Technical Service Information

FORD AX4S (AXOD-E) AND AX4N PRESSURE TAP LOCATIONS

Figure 1
AUTOMATIC TRANSMISSION SERVICE GROUP

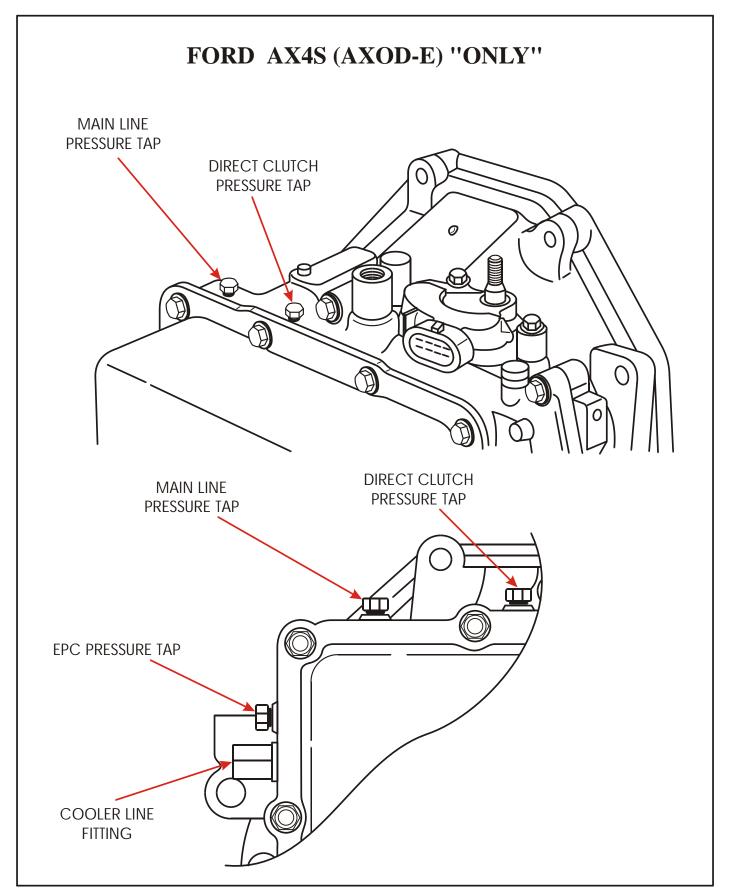
Most technical manuals, including Ford Motor Company manuals, have the pressure tap locations identified wrong. Use the next two pages to correct your manuals at the shop for the correct pressure tap locations.

Refer to Figure 1 for the AX4S (AXOD-E) transaxle pressure tap locations.

Figure 2
AUTOMATIC TRANSMISSION SERVICE GROUP

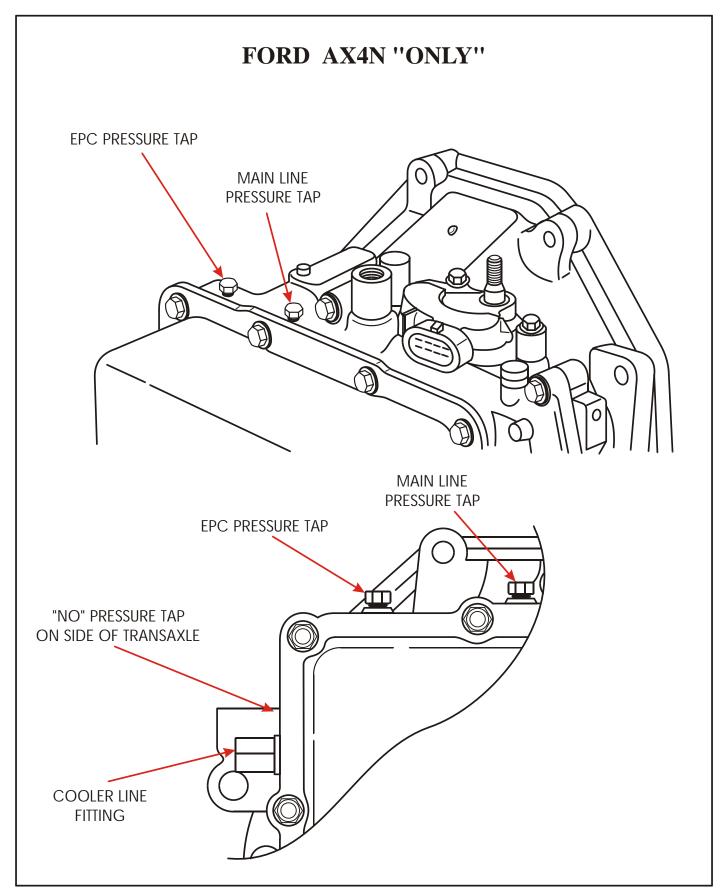
Refer to Figure 2 for the AX4N transaxle pressure tap locations.
